Design Review Subcommittee (DRSC)

Meeting Date: November 22, 2019

SUBJECT: **CUP 18-369, AP 18-389, SPP 18-390 & DSP 18-391, Chevron Car Wash and Expansion, 515 E. Avenida Pico**, a request to expand an existing Chevron service station onto an adjacent vacant parcel, including construction of a new drive-through car wash facility and 2,281 square foot convenience store.

Figure 2 – Comparison of West Elevations (Facing Calle De Industrias)

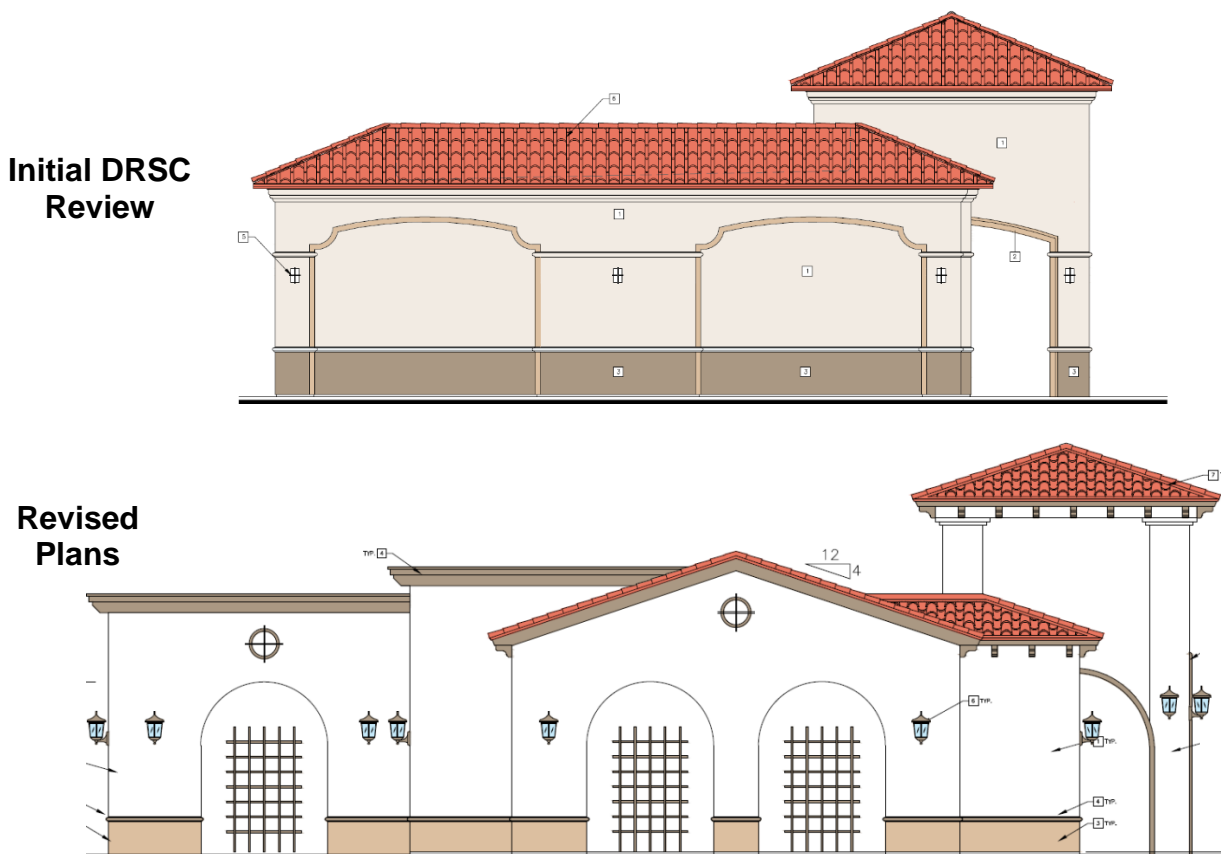
During the initial DRSC review, the Subcommittee found that the overall project trended towards a Spanish Colonial Revival (SCR) style. However, due to the high visibility of the site, the Subcommittee and staff requested modifications that would improve the architectural quality of the project and fully incorporate SCR design. Figure 2 below provides a side-by-side comparison of the elevations submitted during the initial and current DRSC reviews.

The proposed buildings integrate SCR materials and elements such as low pitched roofs, two-piece roof clay tiles, an accent tower at the main entrance, a wooden trellis over the car wash entrance, exposed rafter tails, white stucco, archways, wall recesses, and vertically-oriented windows and doors. The mansard roof was removed and replaced with a flat parapet roof to shield rooftop equipment while providing additional variation in the roof line. The trim details were reduced and used sparingly to highlight openings. Wood materials were incorporated into the project design to provide contrast and variation to the building. Decorative SCR-style light fixtures were also added throughout the building.

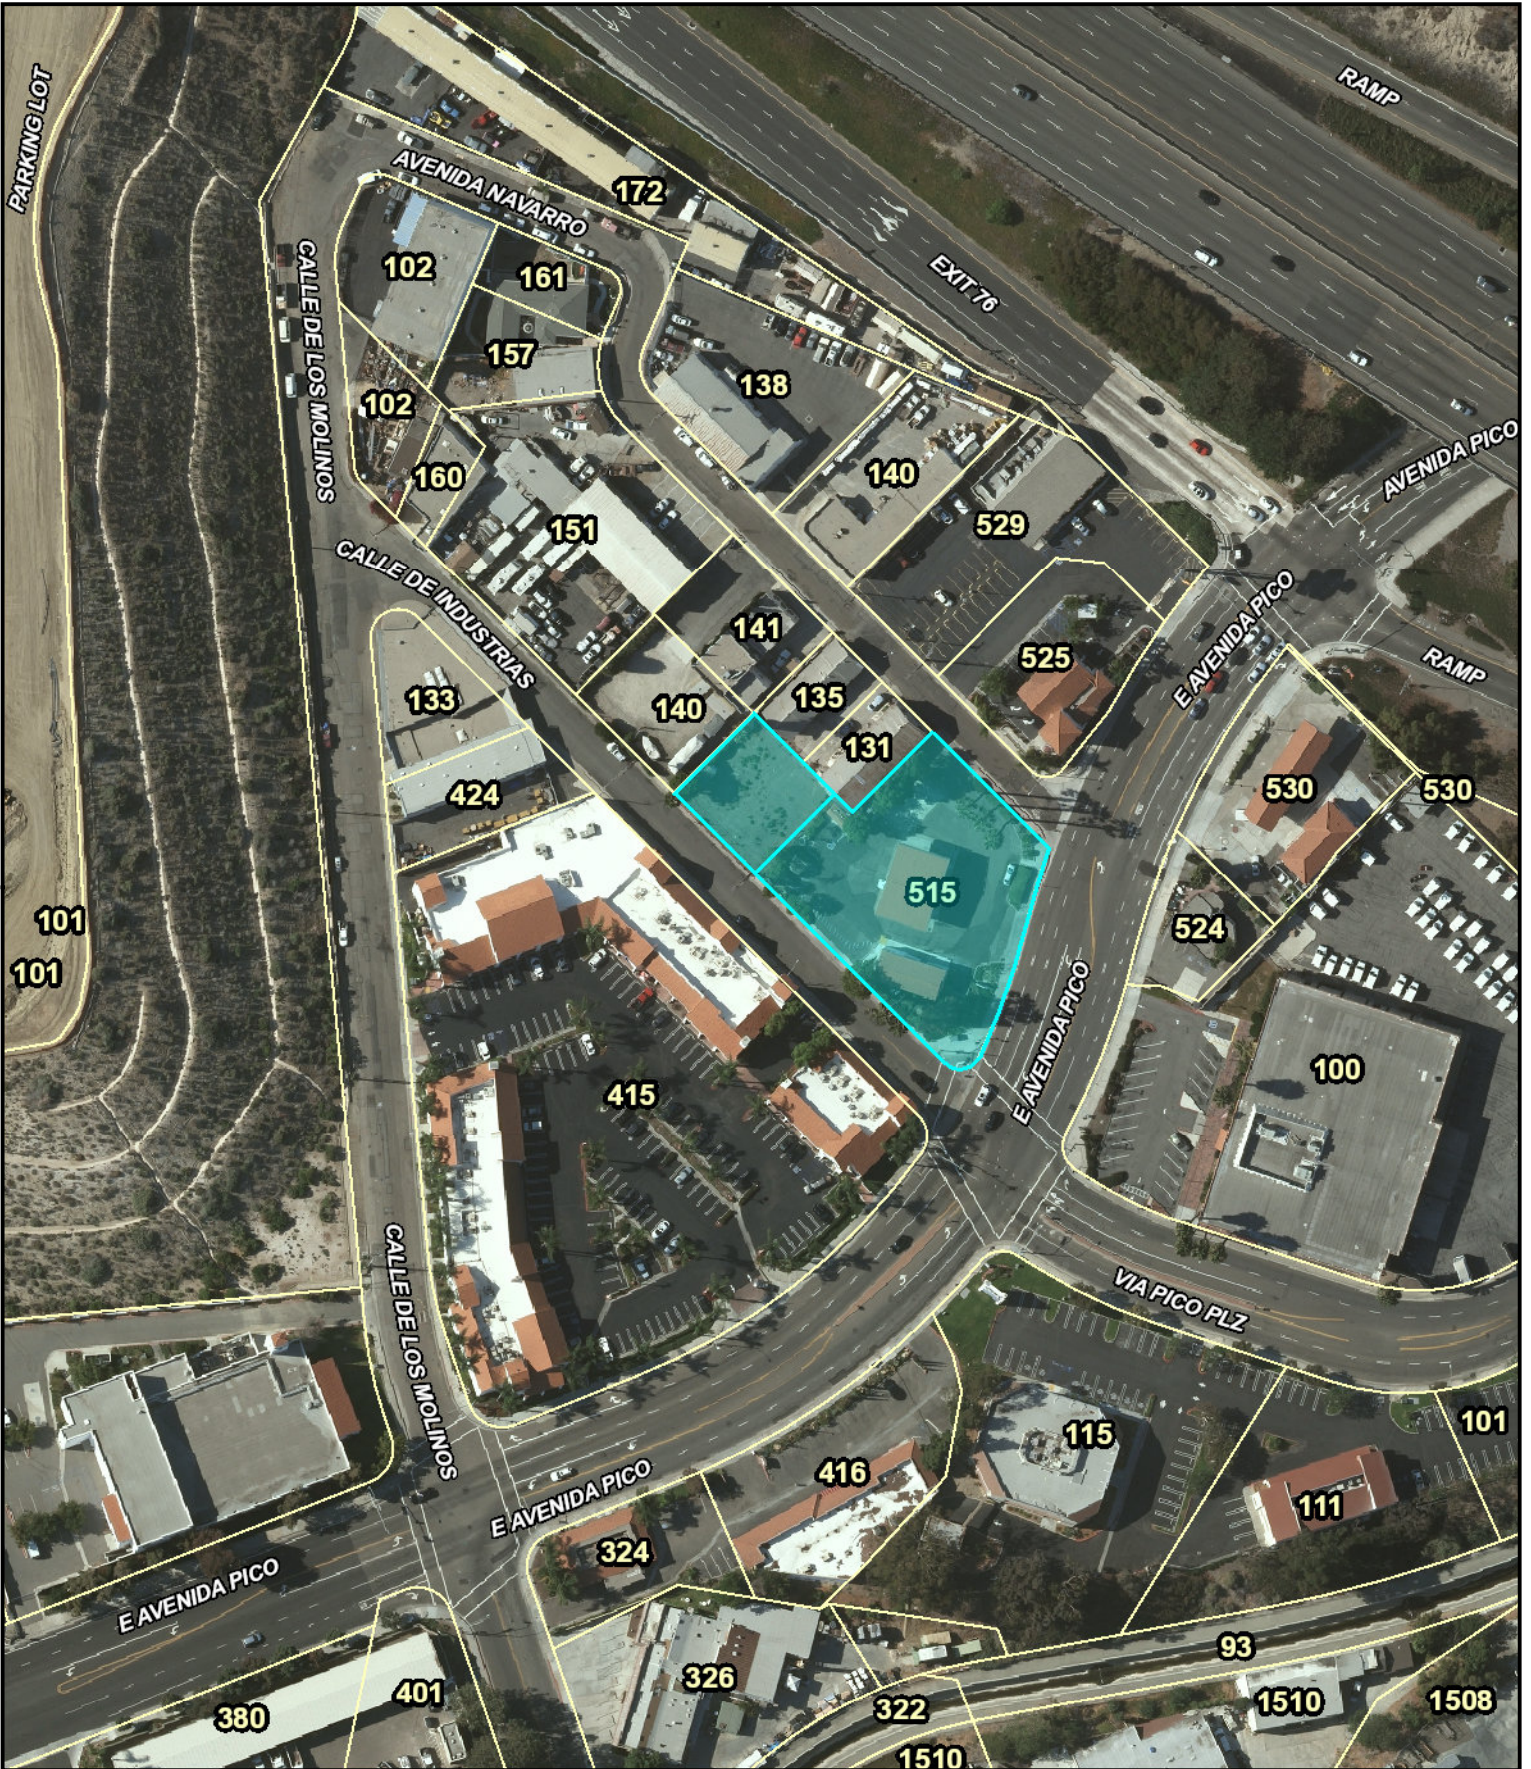
The applicant addressed the majority of the recommendations made by DRSC and staff. However, to further improve the architectural quality of the project and maintain consistent sign designs at service stations, staff recommends the following project modifications.

1. Incorporate a roof into the existing trash enclosure using SCR design elements (i.e., wood trellis).
2. Reorient the convenience store building wall sign slightly so that it is centered on the tower element.
3. Modify wall signage illumination to use pin mounted letters with halo illumination, consistent with recent service station approvals.
4. Use black or dark brown letter faces on the car wash signage to better complement the SCR building.
5. Modify the car wash directional signage to use SCR-style colors and materials. The proposed directional signs use a modern design with metal trim.

PROPOSED CANOPY ELEVATIONS

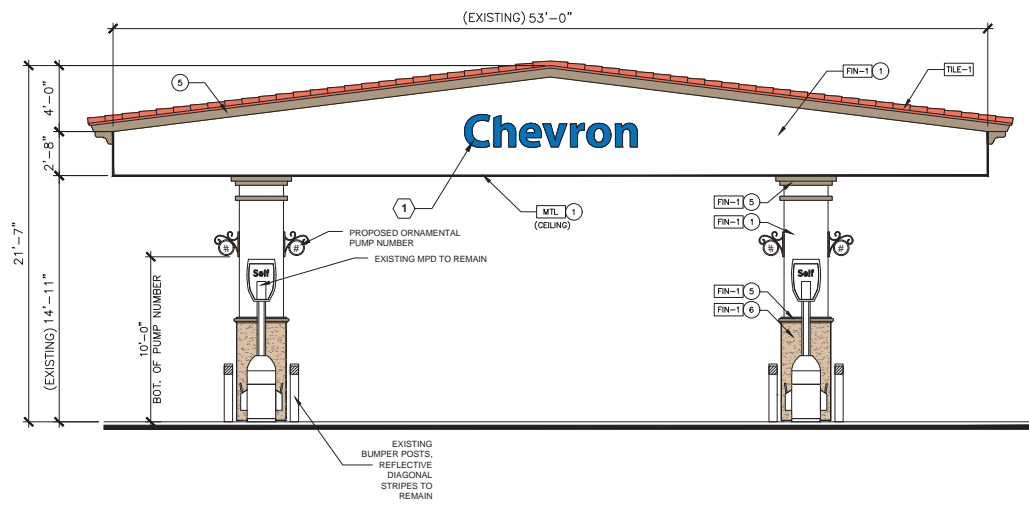
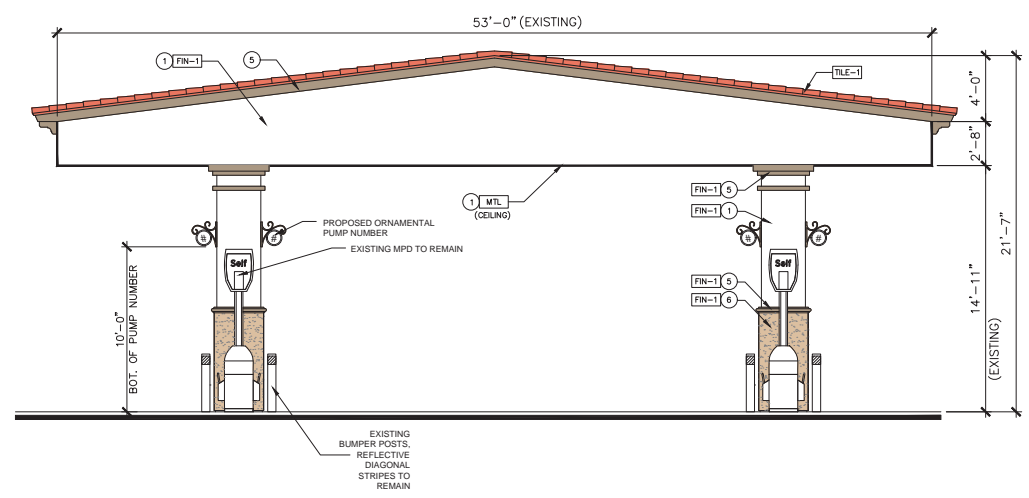
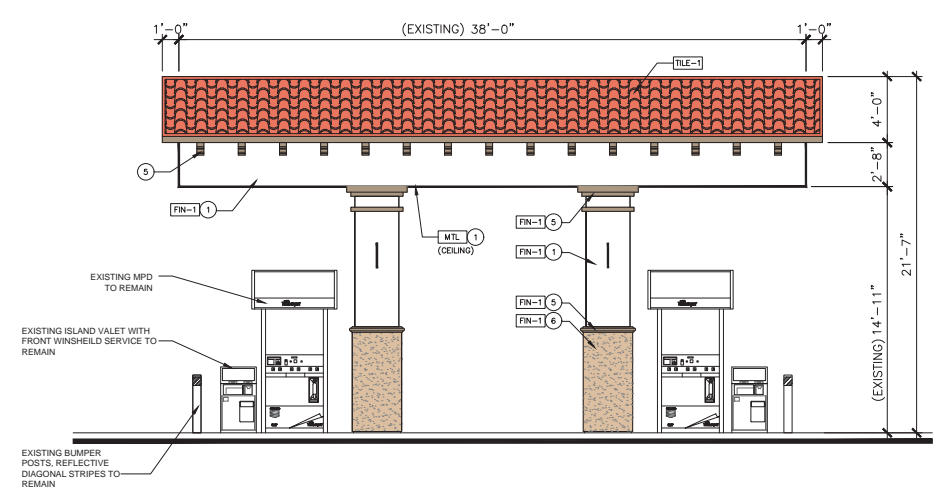
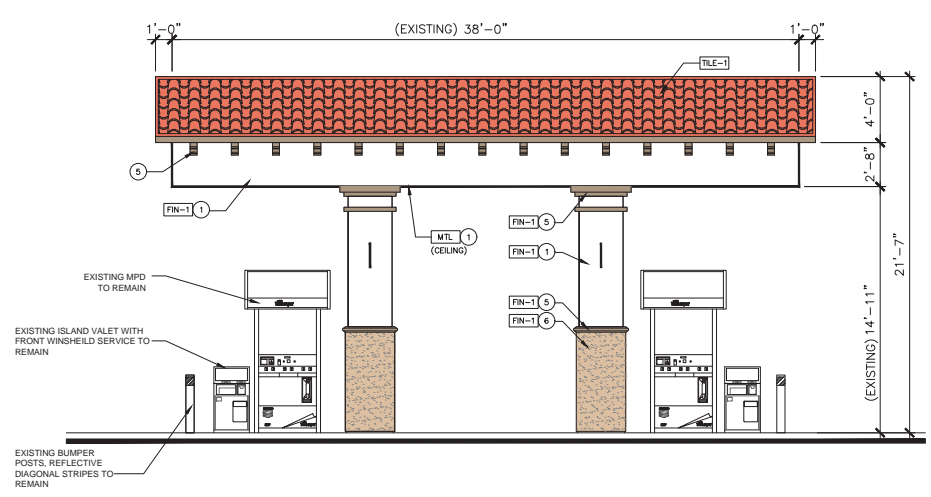
As recommended by DRSC, the applicant proposes façade improvements to the existing fuel canopy to ensure consistent architecture throughout the site. Trim details and cornices are proposed on the canopy to add ornamental elements to the existing structure. Pump numbers would be replaced with a SCR-style ornamental detail (see Sheet CA2.1 of Attachment 4).
